AGENDA

Planning Commission Meeting
Monday, October 20, 2025 @ 5:30 PM

A. Growing Spaces, Facade Variance, 1868 A & B Majestic Drive

A. Final Major Design Review Application, 103 Majestic Drive, Vehicle Sales and Rental Use

Attachment 1: Building Plans
Attachment 2: Site Plans
Attachment 3: Building Official Comments
Attachment 4: Applicant Narrative

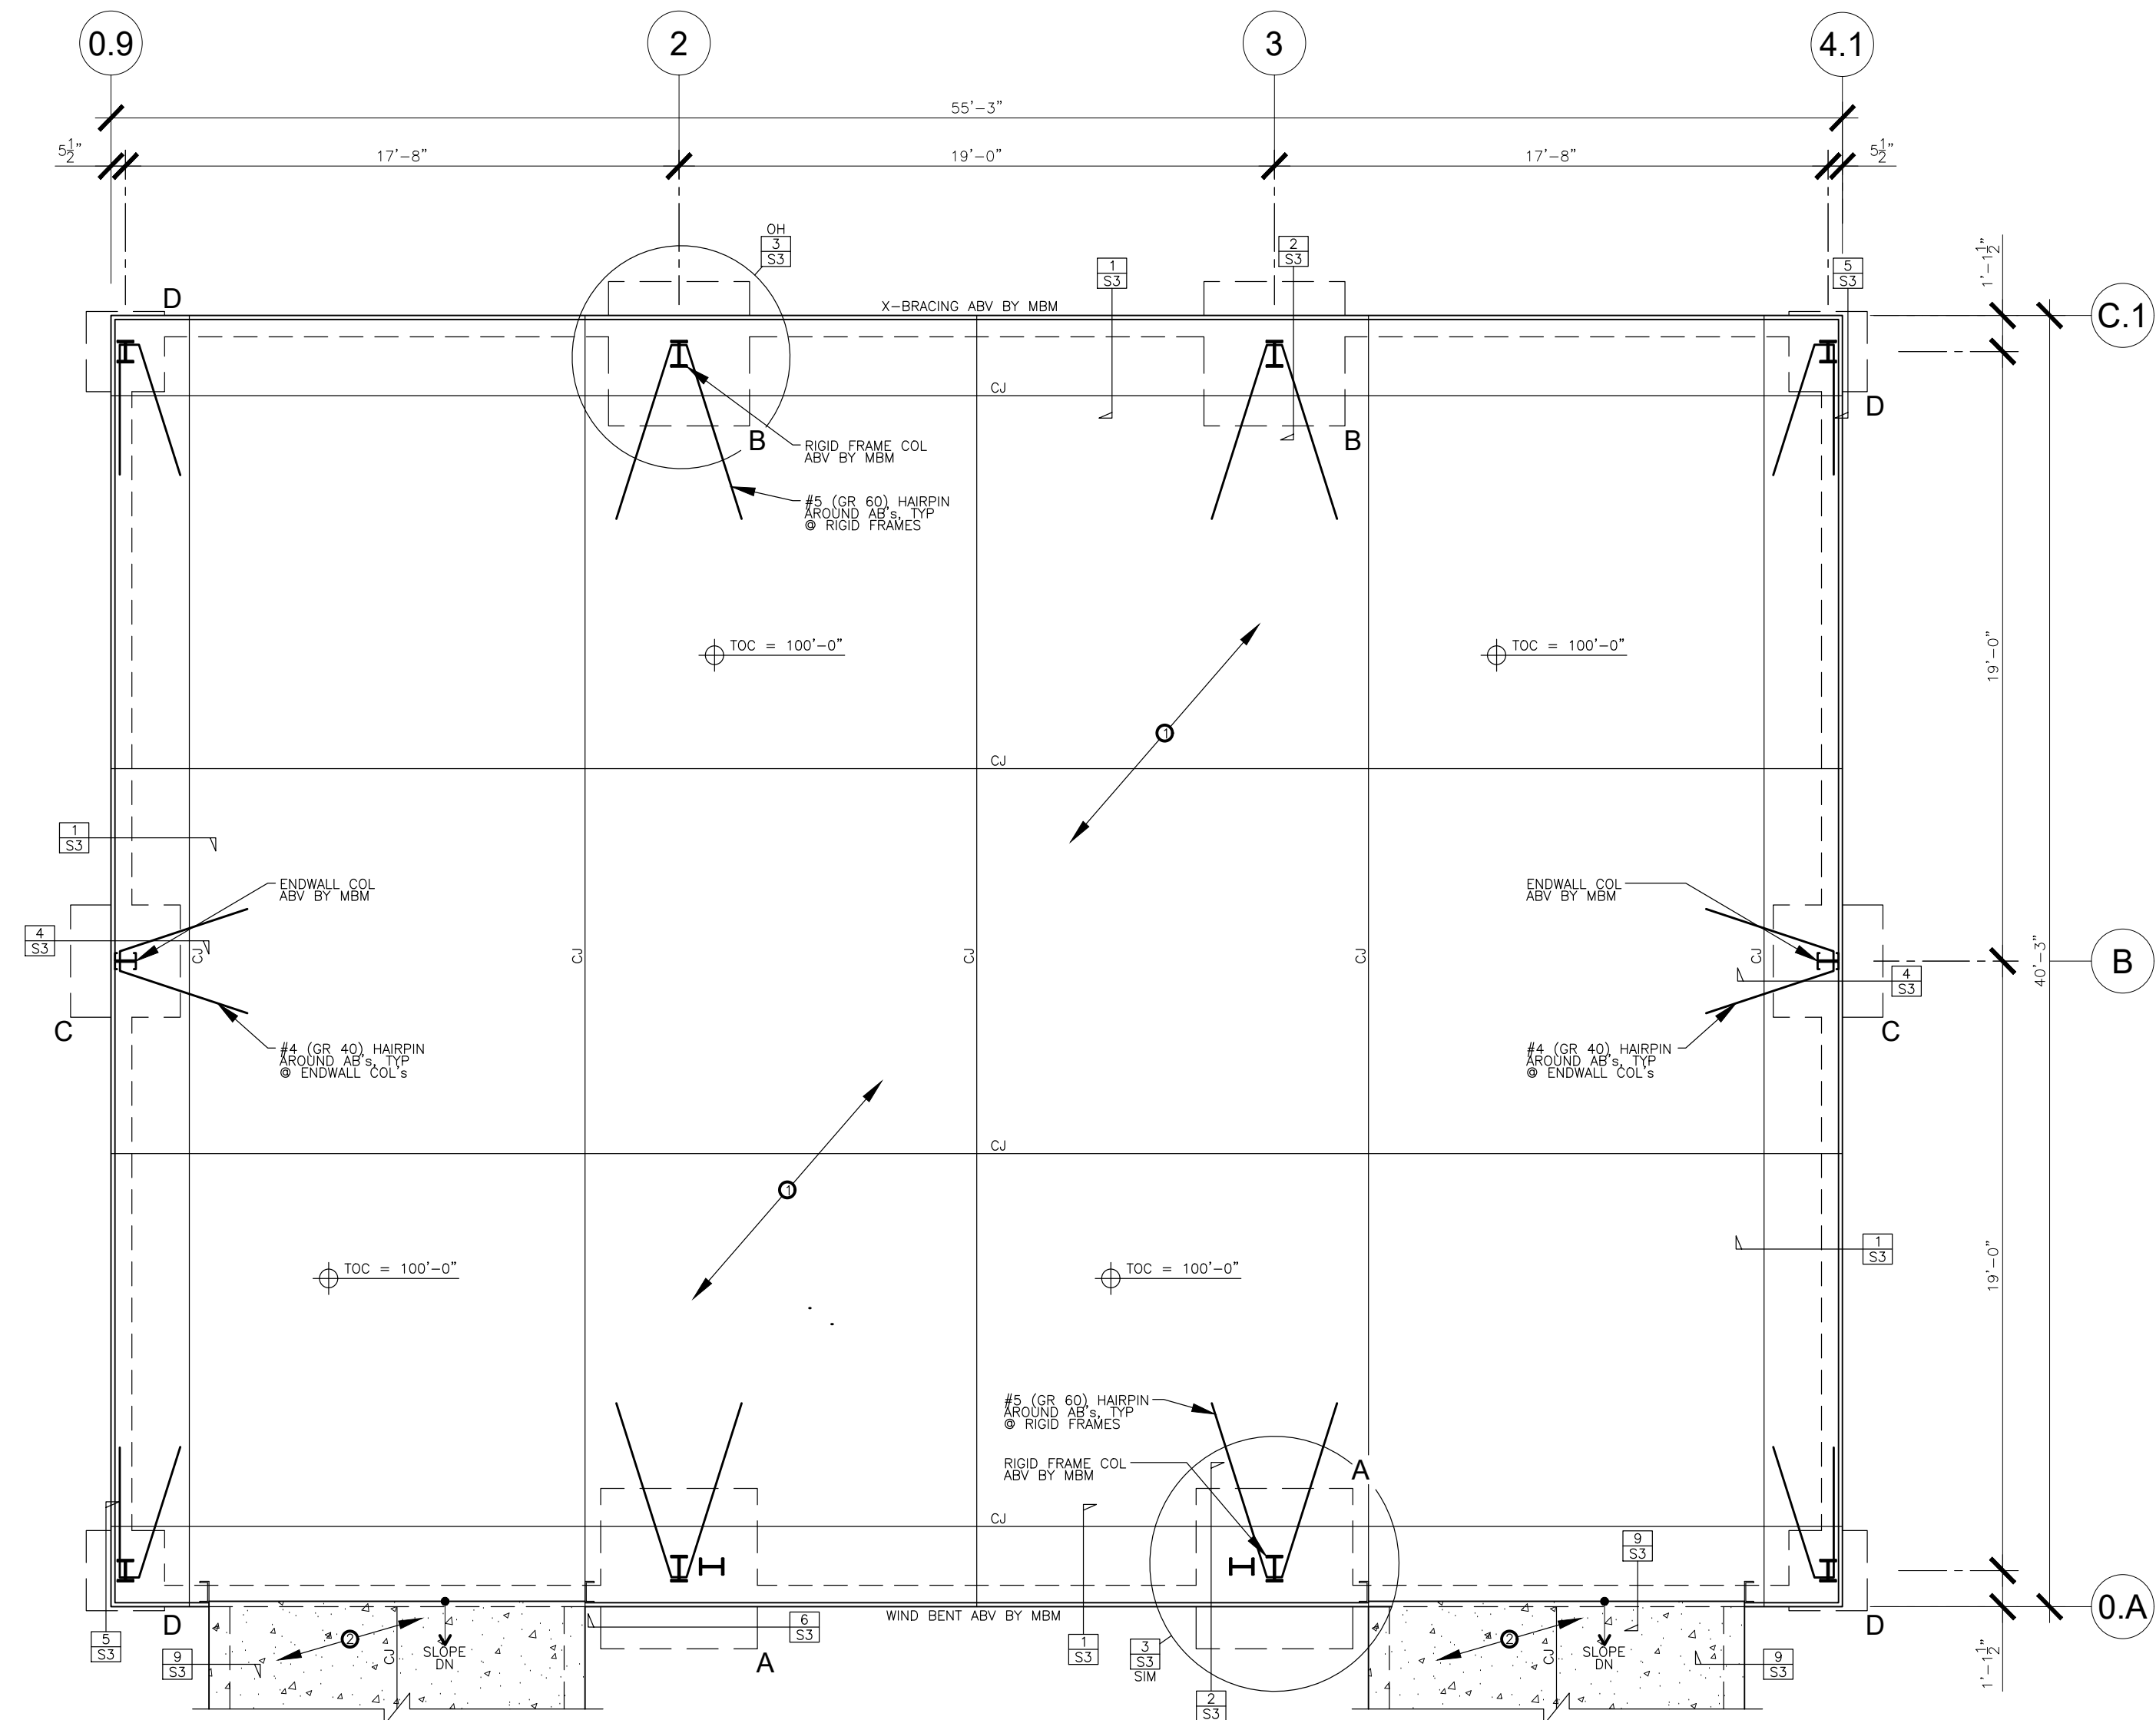
I am reviewing your submittals for the new building project. We will need a set of Architectural drawings with a building code analysis for your project. The Architectural drawings will be required by planning and the Fire Department as well.

Due to the simplicity of the project the drawings can be minimal. Drawings should include a code analysis, floor plan, and elevations.

- 2.Applicant must submit a set of Architectural drawings with a building code analysis to the Town of Pagosa Springs Building Department, to include a code analysis, floor plan, and elevations (Building Official Review).
